A G E N D A
JAMES CITY COUNTY CHESAPEAKE BAY BOARD
REGULAR MEETING
County Government Center, Building F
101 Mounts Bay Road, Williamsburg, Virginia 23185
February 12, 2020
5:00 PM

SUBJECT: Appeal - Recreation Area A, Stonehouse

SUBJECT: Appeal of Denial of Erosion and Sediment Control Plan E&SC-19-0047 - Stonehouse Recreation Area A, 9351 Six Mount Zion Road

E&SC-19-0047

JOB NO.: 34599/024
SHEET NO.: C-1.0

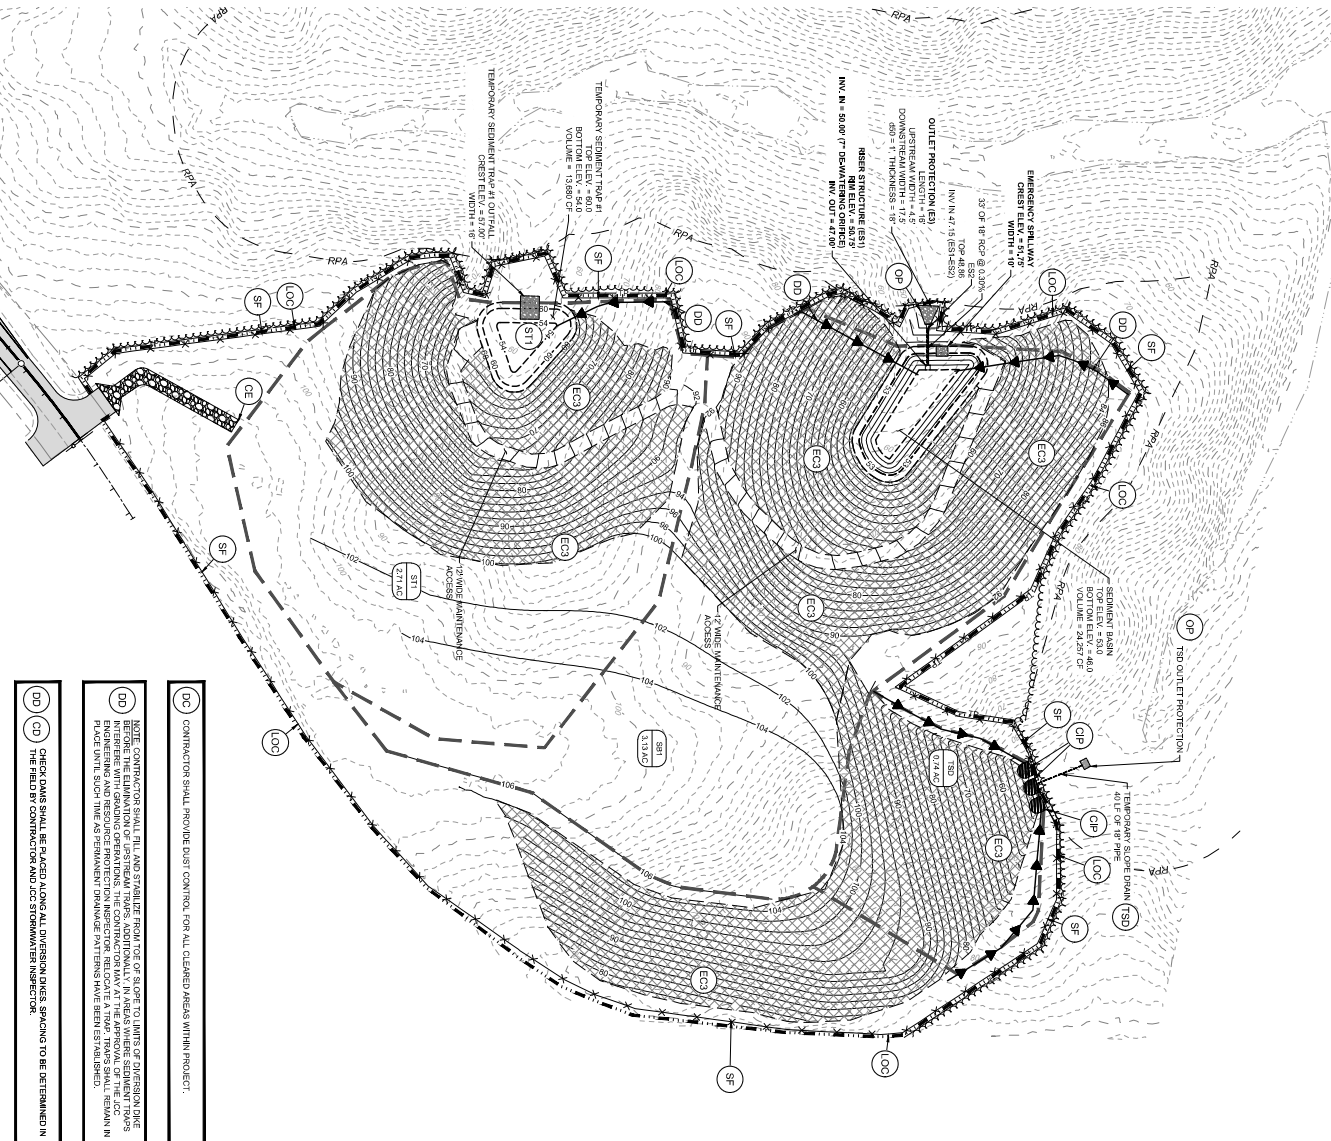
According to the site narrative that was provided on the E&SC plan, the project encompasses two phases. The first phase provides temporary sediment traps and a sediment basin. The second phase encompasses stockpiling soil within the valleys of the site. Per the project description on the submitted E&SC plan, once the site is stabilized, a sediment trap and sediment basin will remain in place until future development happens.

A typical stockpile plan, like the one already approved for the Tract 3 development, has a mound of soil upon a relatively flat area. This plan proposes to create a relatively flat area by filling in ravines up to 40 feet in depth. Clearing and filling of this portion of Tract 3 goes directly against Section 23-9(b)(1) and (2). Further, this proposed stockpile plan has RPA impacts for the outfalls of the temporary sediment traps and basin that have not yet been addressed.

Staff contends that the Developer has an approved, permitted, and bonded stockpile area for the Tract 3 development. Staff has concerns with clearing existing forested land for a second stockpile area, with an E&SC plan that was not submitted as part of a site plan or subdivision plan. The parcel for Recreation Area A has steep slopes and highly erodible soils. The Division has had enforcement issues related to construction practices within Tract 3 over the past two years. Staff recommends to the Board that the Erosion and Sediment Control plan, E&SC-19-0047, for Recreation Area A be denied.
